KSZ8041 Silicon Errata and Data Sheet Clarification

This document describes known silicon errata for the KSZ8041 family of devices, which includes the following:

Module 2: Pin Strapping failures due to 1.8V core power slow ramp-up

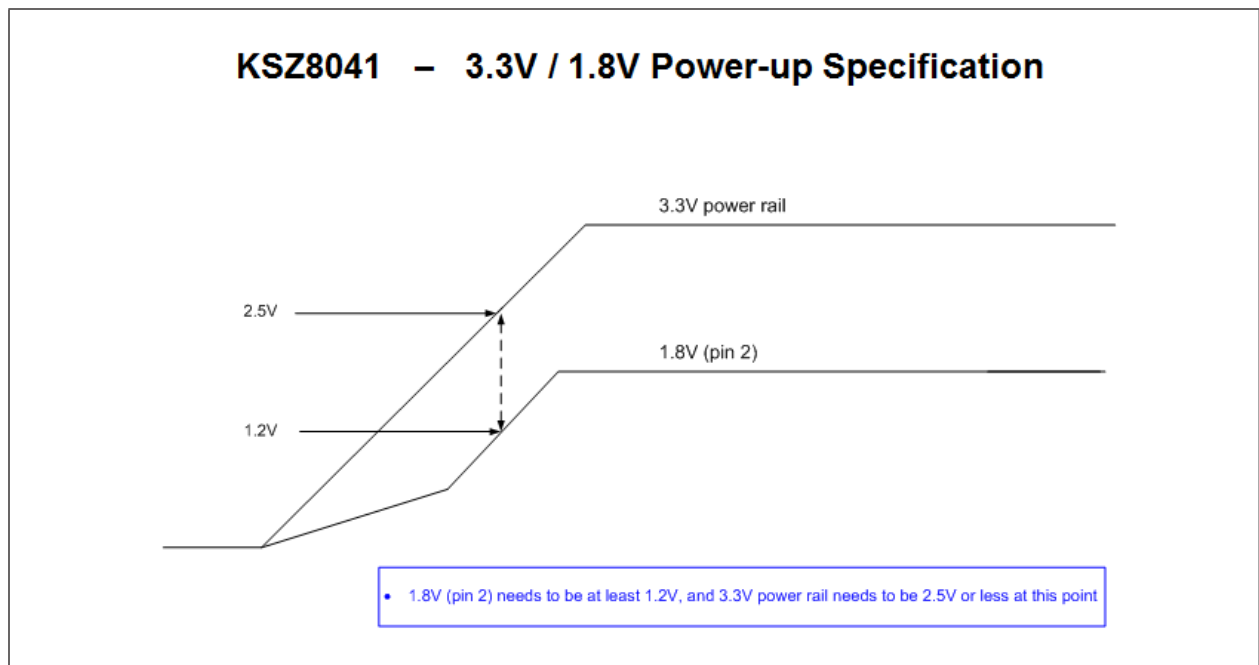
A small percentage (<1%) of devices can potentially encounter pin strapping failures with fast 3.3V supply rise times (<150us) or slow core rail rise times, due to a large bulk storage capacitor value (10uF or greater) for the 1.8V core.

When this errata occurs, pin strap values may not be correctly latched.

Reduce the 1.8V core bulk storage capacitor from 10uF to 1.0uF and ensure the 3.3V supply rise time is 250us or greater.
